# 3812 - Addendum 1

To	Kristen Haskell	Date	10/03/25
For	Long Creek Youth Development Center Ceiling Replacement	Project No.	BGS# 3812 SMRT# 25014

This addendum forms a part of the bidding and contract documents.

AD102

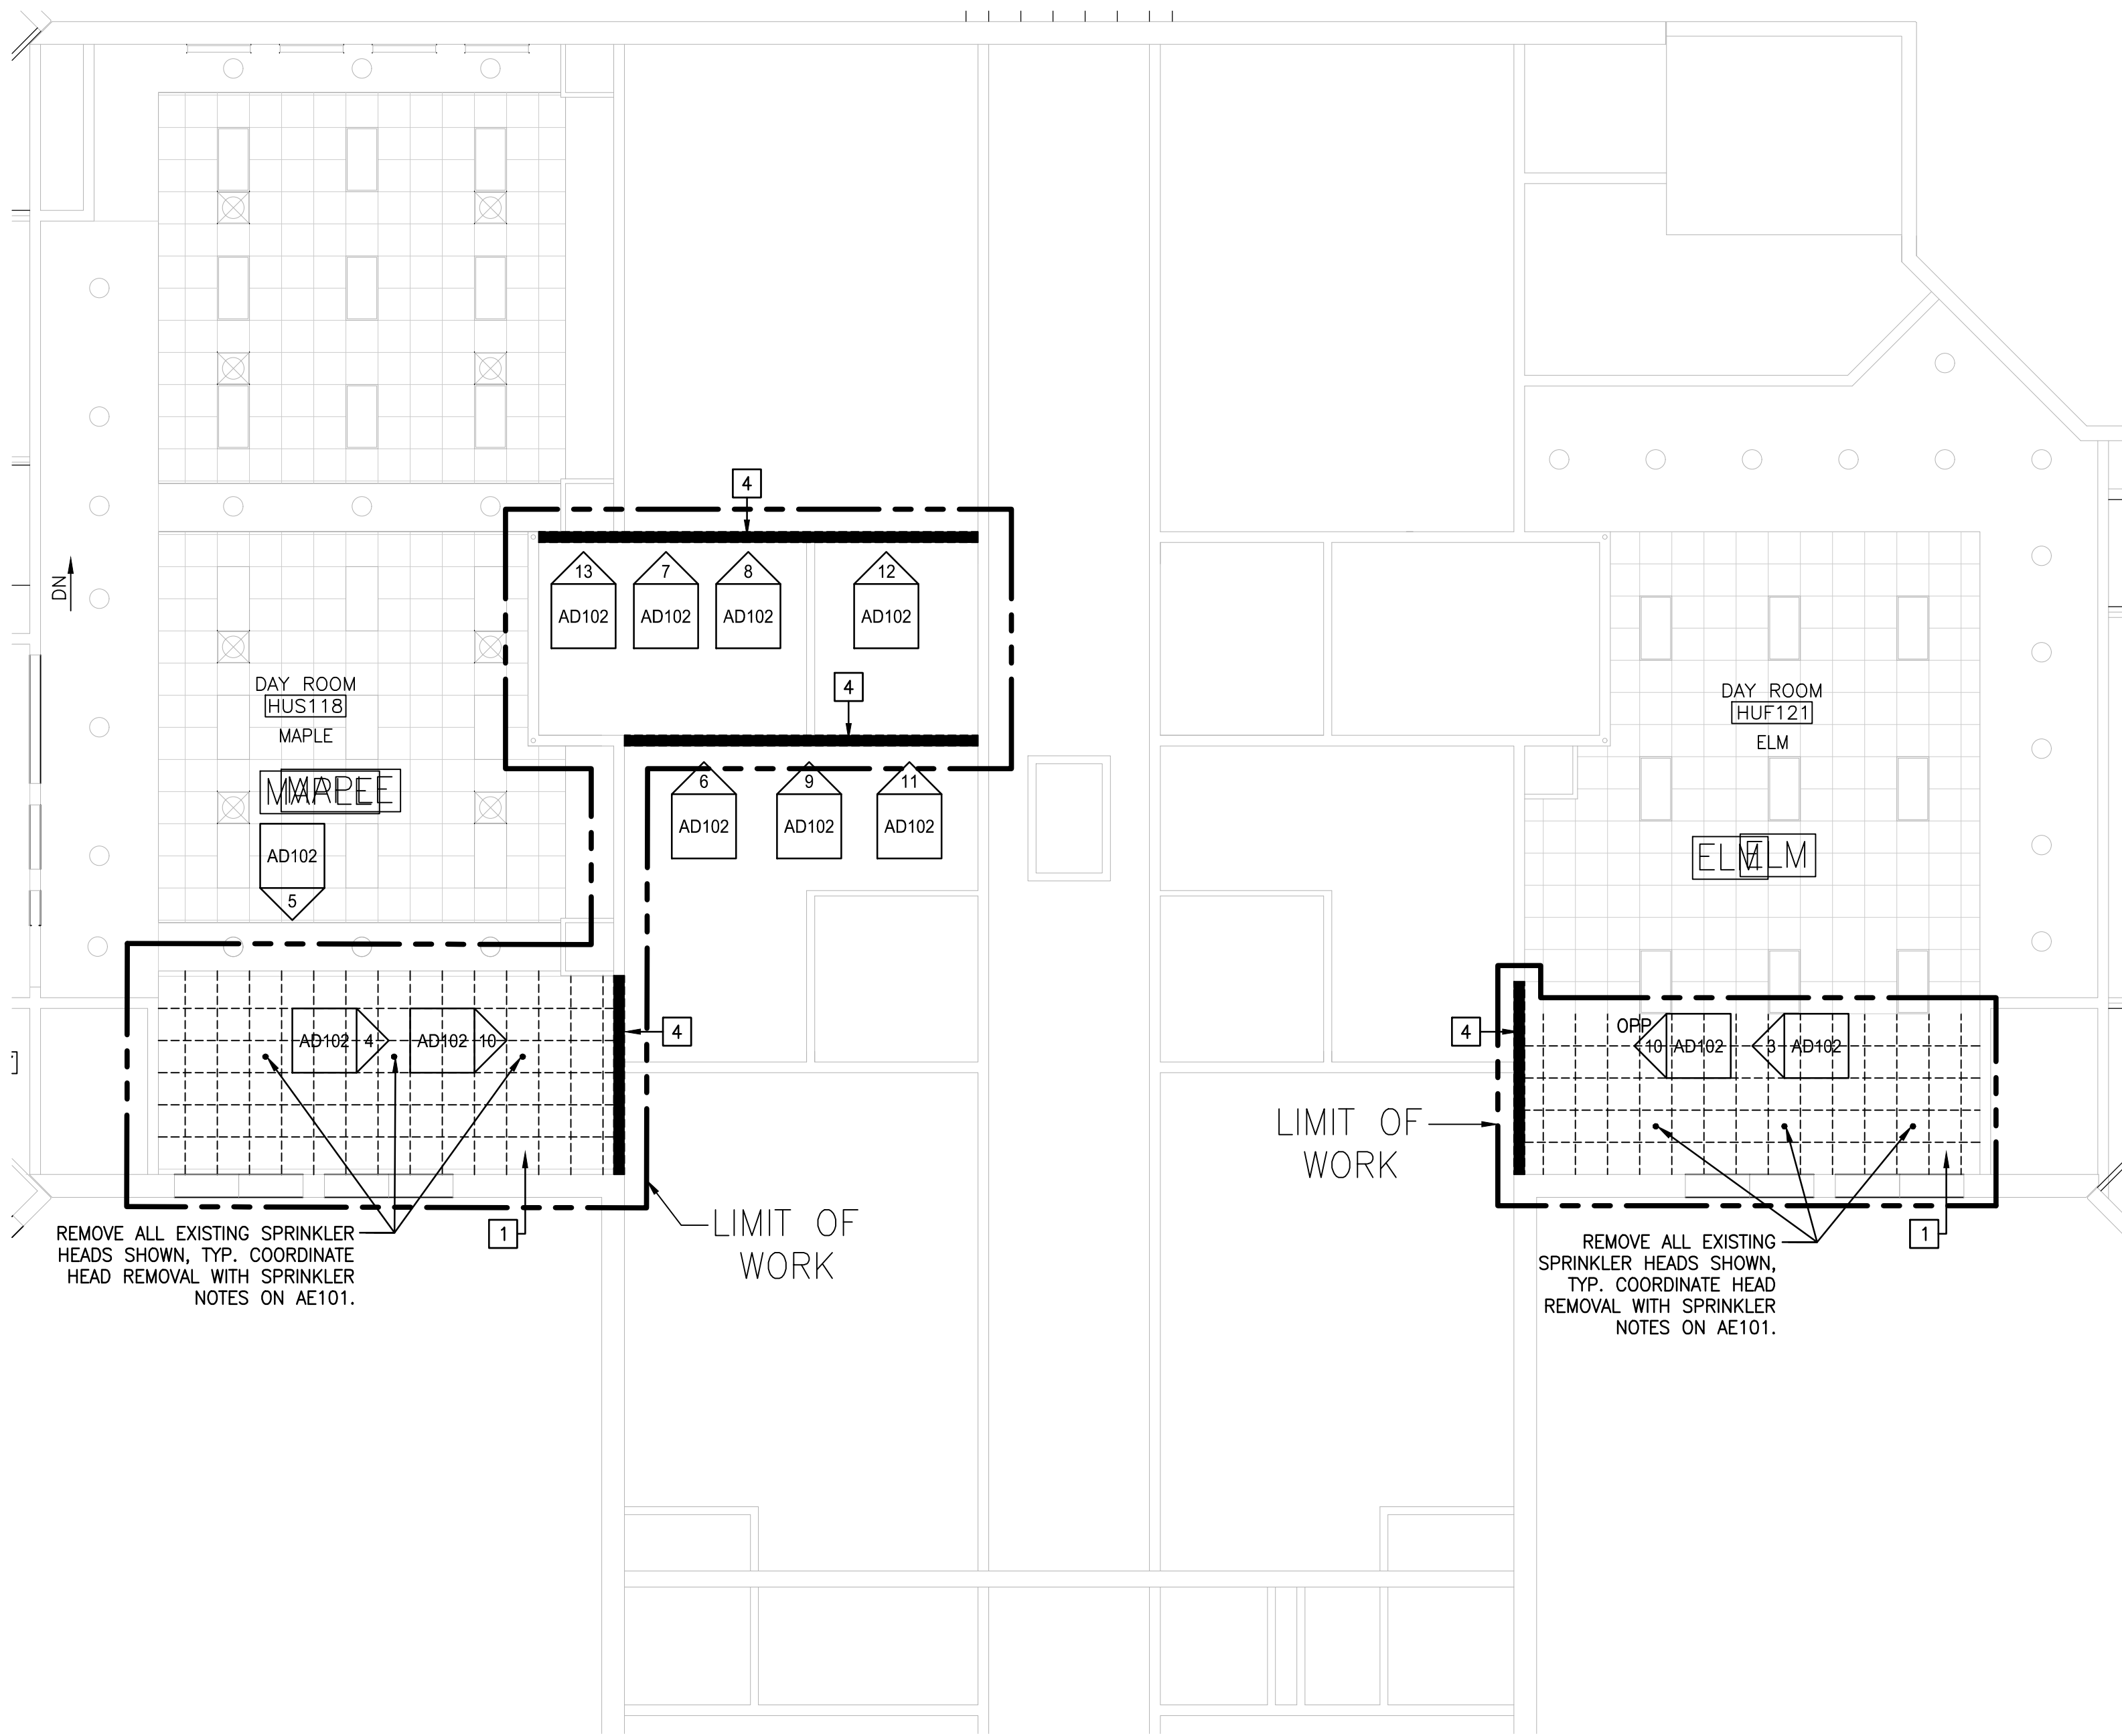
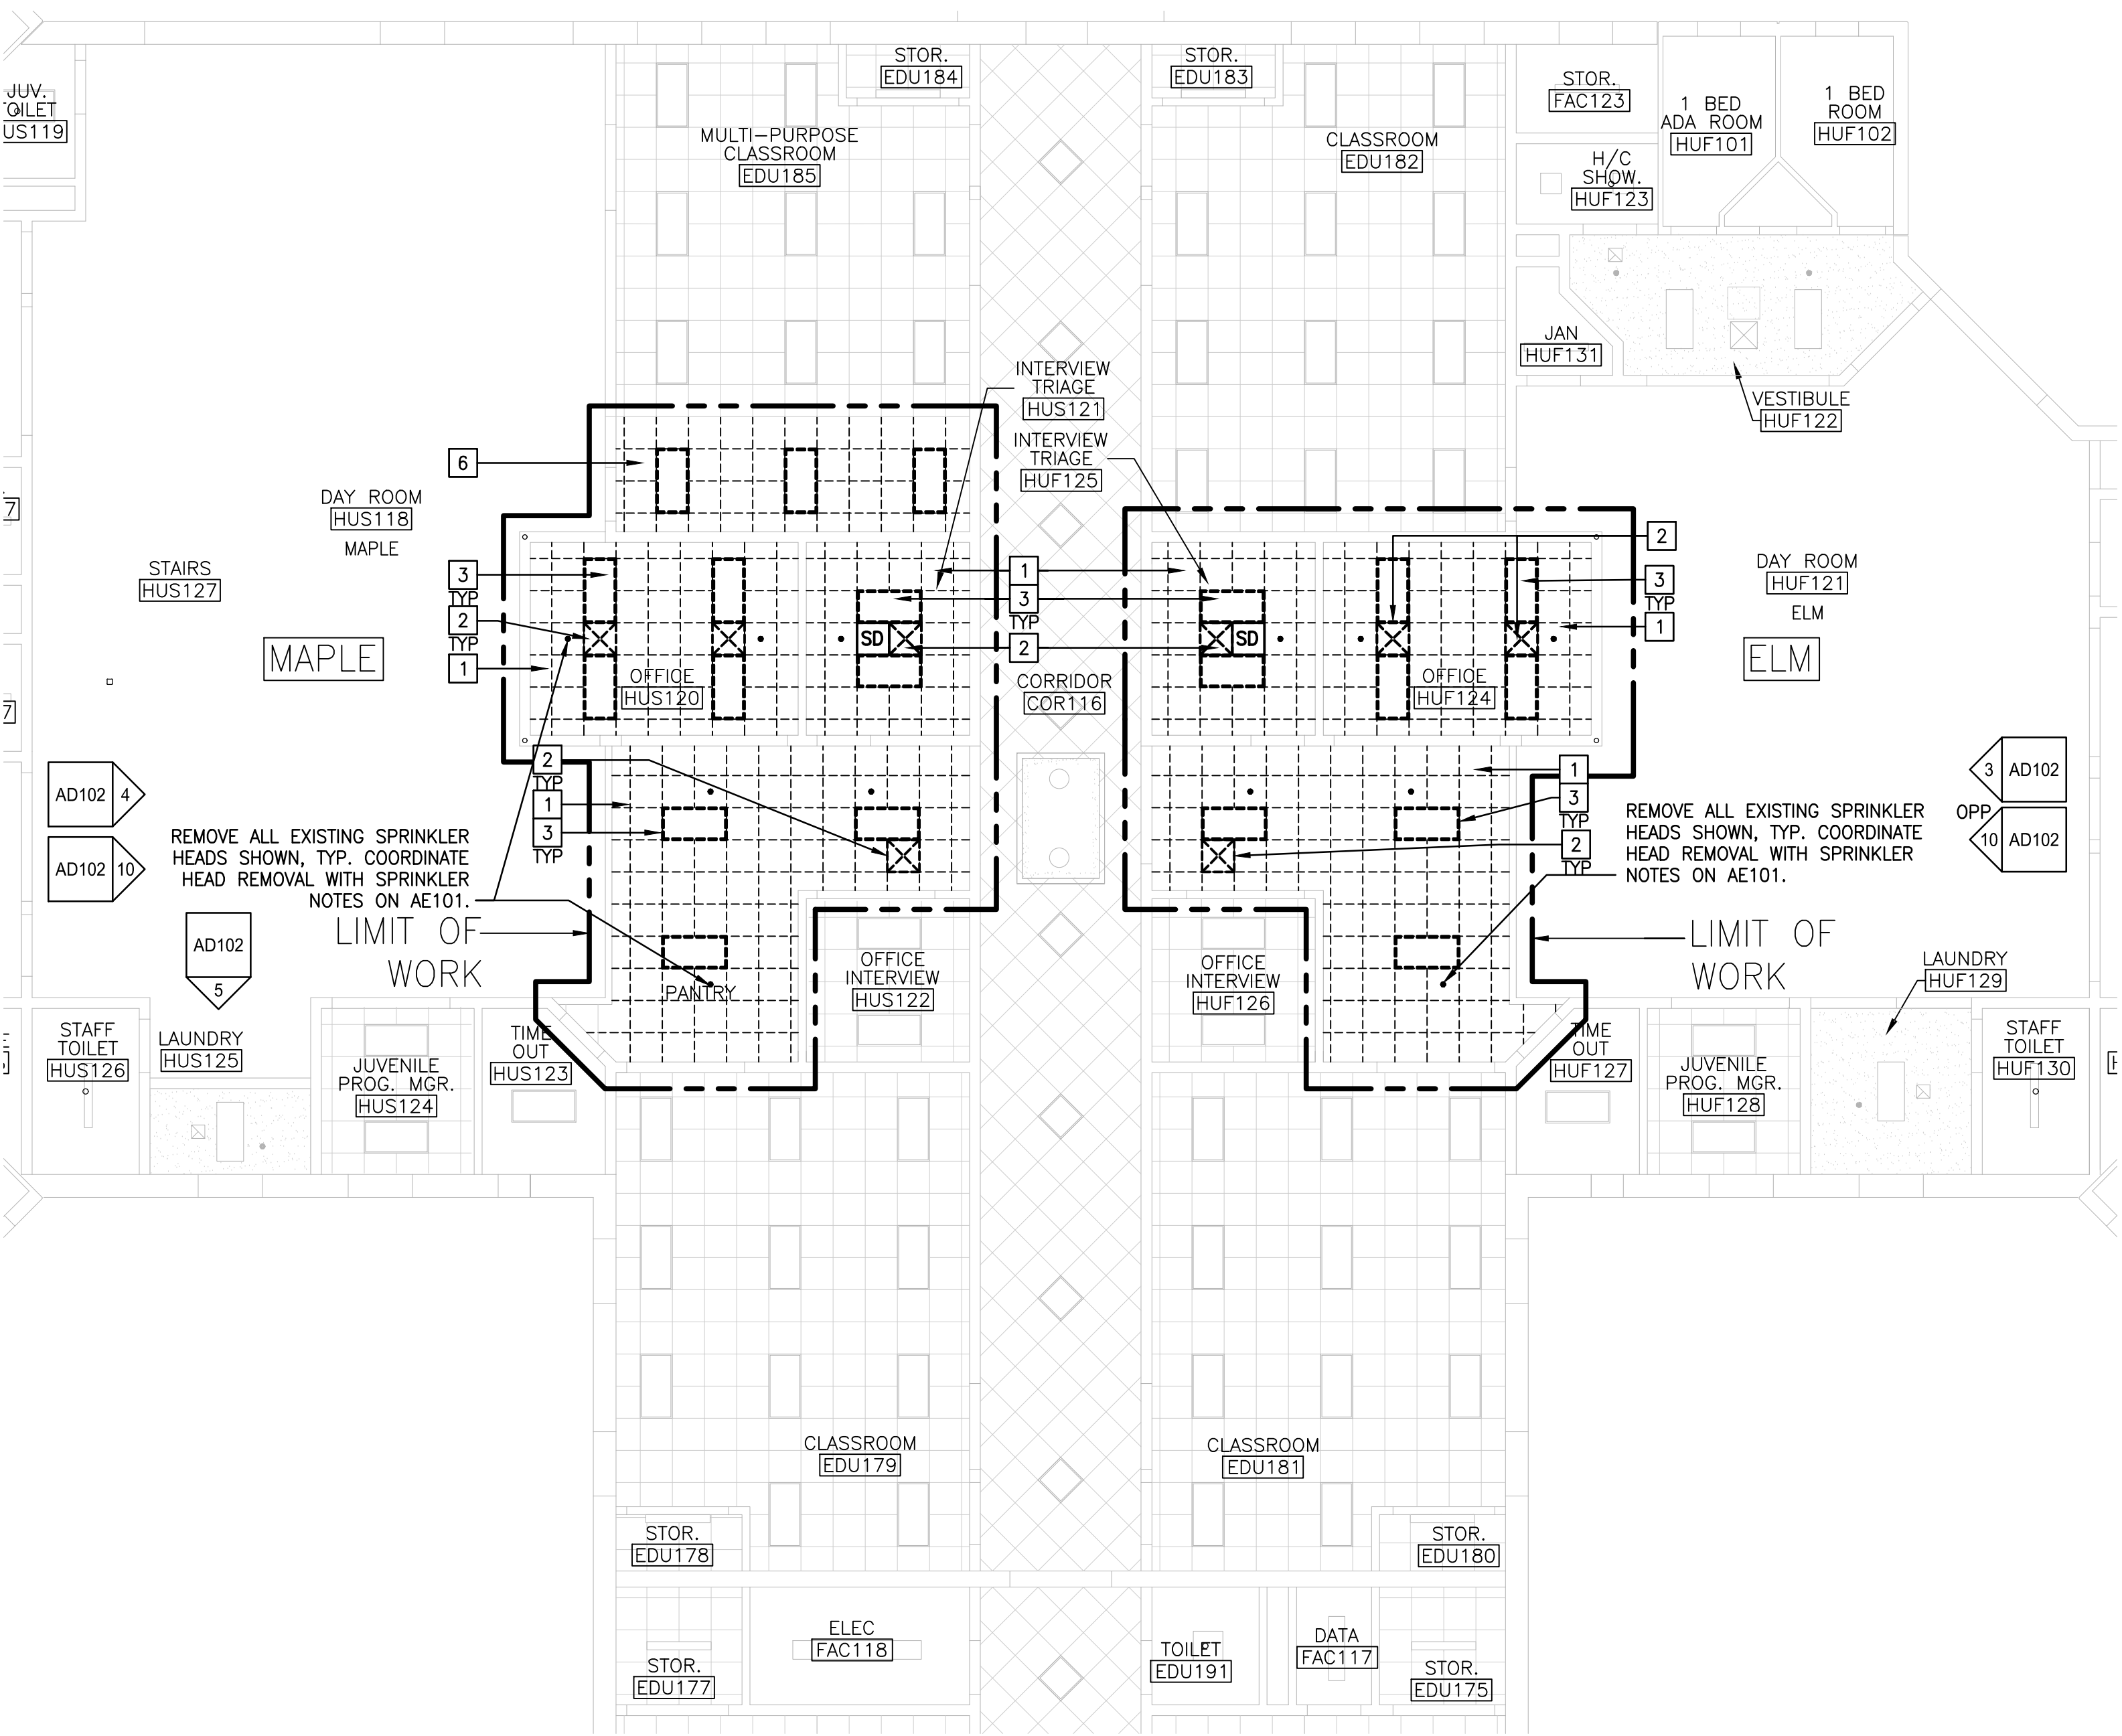
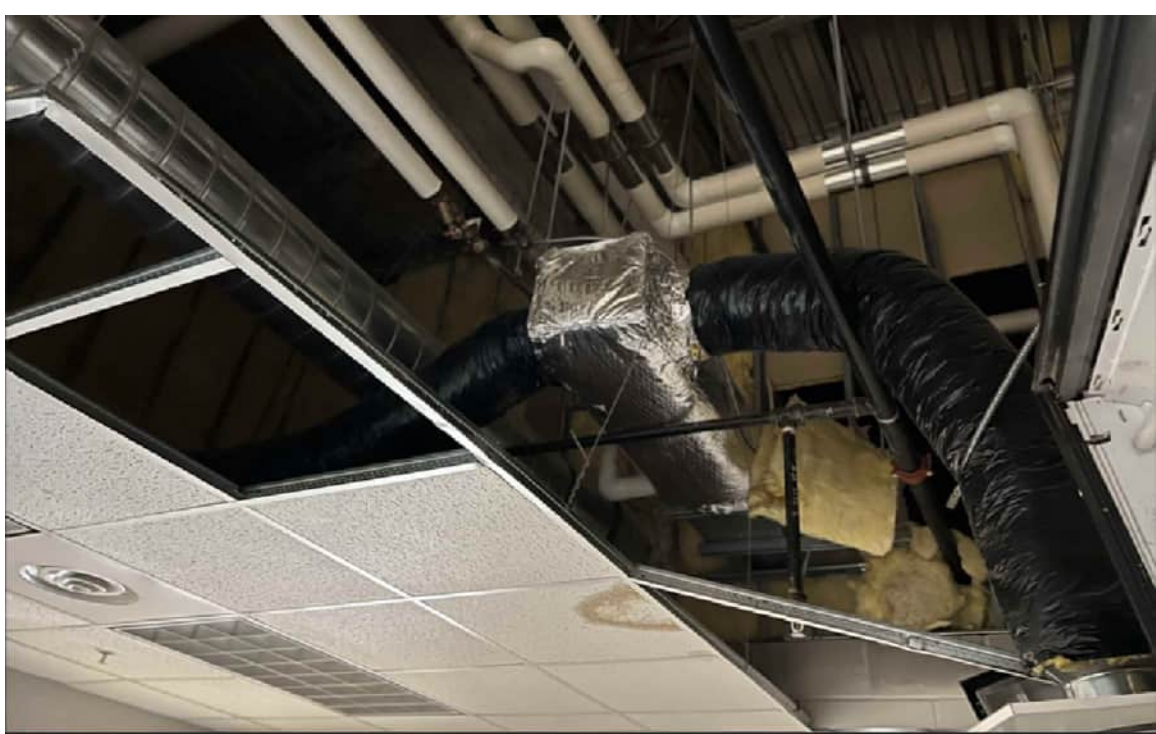
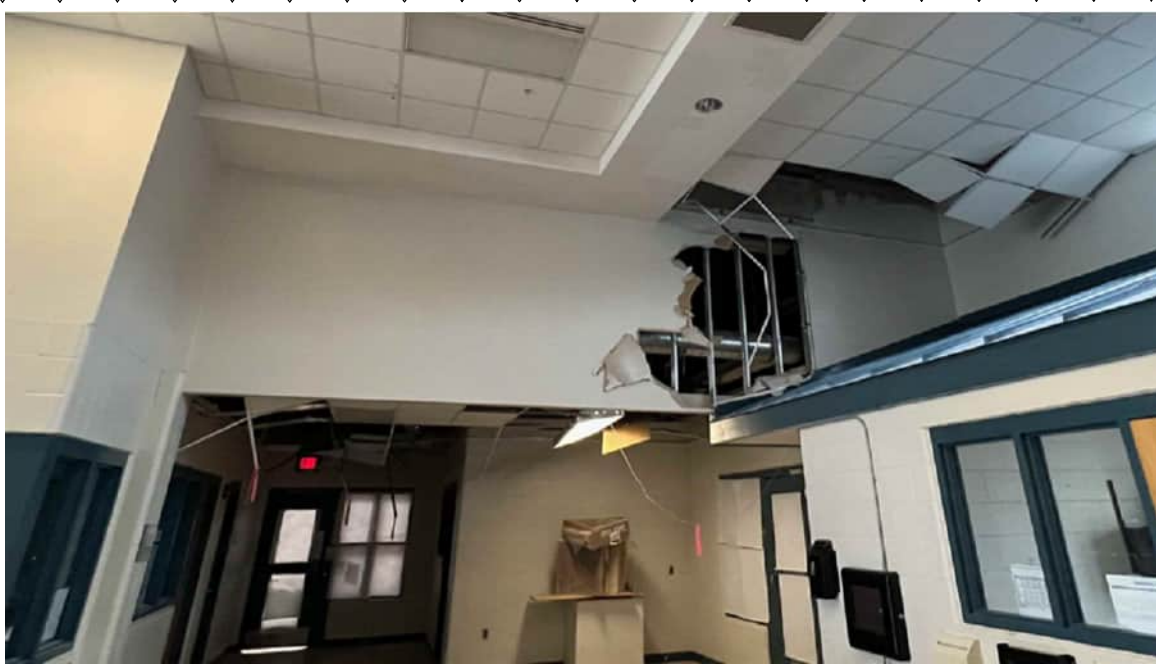
<b>The project will start immediately following a fully executed contract, which can't be predicted. For bidding purposes, assume 2 weeks following the date of bid opening. The project substantial completion and final completion dates are indicated in project manual section 00 11 13 "Notice to Contractors".</b>
Q13.	The specs do not include spec section 014100 Special Inspections. Please confirm there are no special inspections required. RESPONSE: <b>Confirmed.</b>
Q14.	Please confirm the contractor is not responsible for permitting. RESPONSE: <b>The contractor is responsible for building permitting.</b>
Q15.	Is there any hazardous or contaminated materials that will be encountered during construction? RESPONSE: <b>None that we're aware of or anticipate being encountered.</b>
Q16.	On the drawing AD102 there are spaces for existing photos, can these be provided? RESPONSE: <b>Refer to the attached revised drawing AD102 for photos.</b>
